City of De Pere

ADDENDUM NO. 1
PROJECT 19-05
SIDEWALK, CURB AND CONCRETE PAVEMENT REPAIR

ADDENDUM NO. 3
PROJECT 19-05
SIDEWALK, CURB AND CONCRETE PAVEMENT REPAIR

ADDENDUM NO. 4
PROJECT 19-05
SIDEWALK, CURB AND CONCRETE PAVEMENT REPAIR

EXHIBIT Q

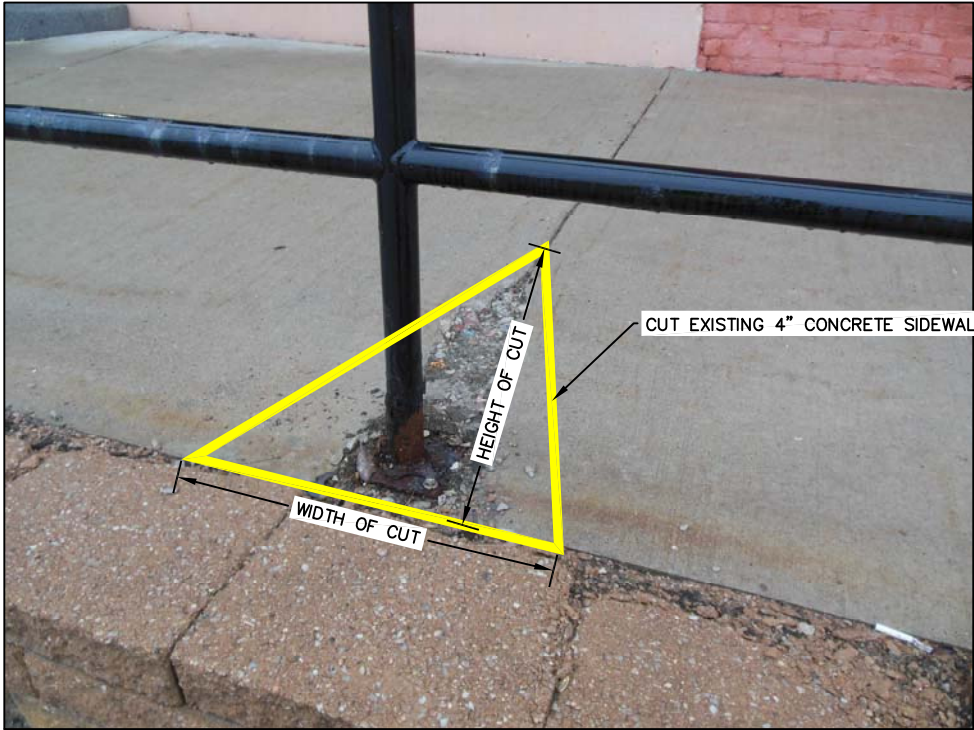
The purpose of this addendum is to remove the installation of the four-inch concrete sidewalk at the VFW Park Playground and insert two separate railing and associated sidewalk repairs.

1. Insert Exhibit Q – 103-109 N Sixth Street Sidewalk and Railing Repair
2. Insert Exhibit R – N Broadway Street Railing Repair

1. Insert Exhibit Q – 103-109 N Sixth Street Sidewalk and Railing Repair
2. Insert Exhibit R – N Broadway Street Railing Repair

RETROFIT NEW FENCE FOOTINGS TO MATCH EXISTING FOOTINGS AT THE FOLLOWING LOCATIONS

NOTE:
1. FENCE TO BE REMOVED, SANDBLASTED, REPAIRED, REPAINTED AND REINSTALLED.
